ROHDE & SCHWARZ

Release Notes

Firmware Update R&S[®] ESIB 4.35

for R&S[®] ESIB7, R&S[®] ESIB26, R&S[®] ESIB40

CONFIGURATION MODE - EMI RECEIVER menu:

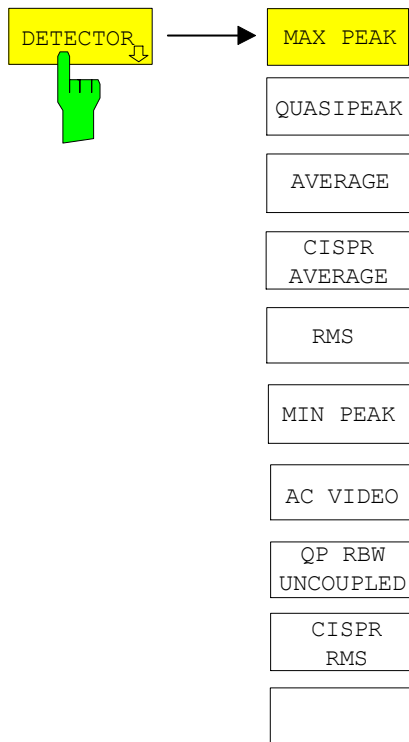
The weighting modes that can be selected have been extended by the detector CISPR RMS.

The *DETECTOR* softkey opens a submenu to select the detector.

Multiple detection is activated by switching on up to four single detectors. The MIN PEAK, RMS and AC VIDEO detector cannot be switched on simultaneously.

Softkey AC VIDEO is available only if the instrument is equipped with the linear video output (option ESIB-B1).

TRACE menu

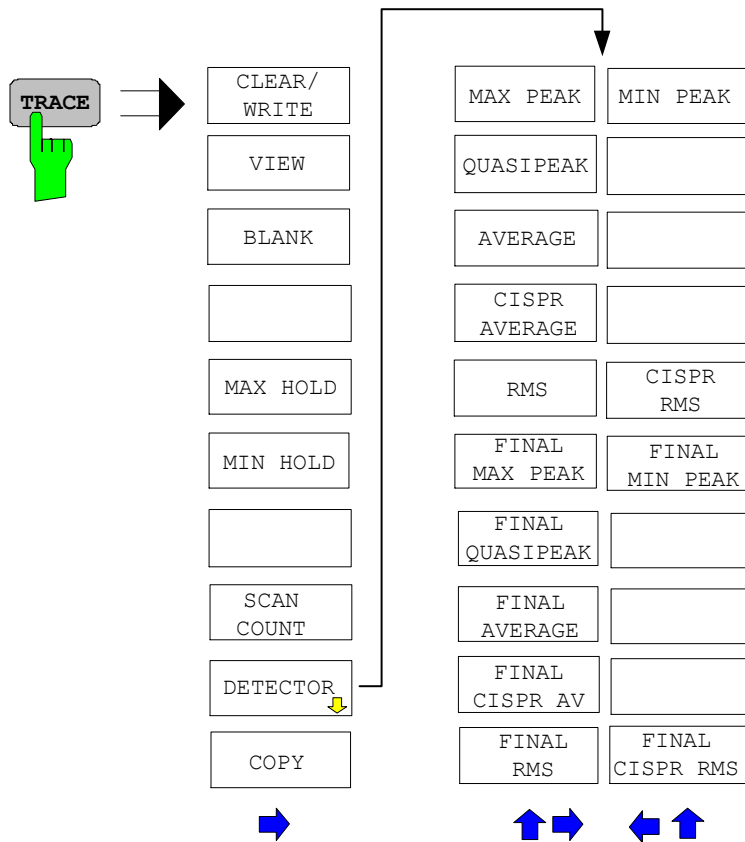
The *CISPR RMS* softkey activates the weighting detector according to a proposed amendment of CISPR 16-1-1 (CISPR/A/628/CD). The CISPR RMS average detector supplies a weighted reading of the input signal. When measuring the RMS-average according to the proposed amendment of CISPR 16-1-1, the maximum value of the RMS-average during the measurement time is displayed. The detector is used, for example, to measure pulsed sinusoidal signals with a low pulse repetition frequency. It is calibrated with the RMS value of an unmodulated sinusoidal signal. Averaging is with lowpass filters of the 2nd order (simulation of a mechanical instrument).

IEC/IEEE bus command :SENS:DET CRMS
:SENS:DET:REC CRMS

The *FINAL CISPR RMS* softkey selects the weighting rms detector according to CISPR 16-1-1 for the final measurement.

IEC/IEEE bus command :SENS:DET:FME CRMS
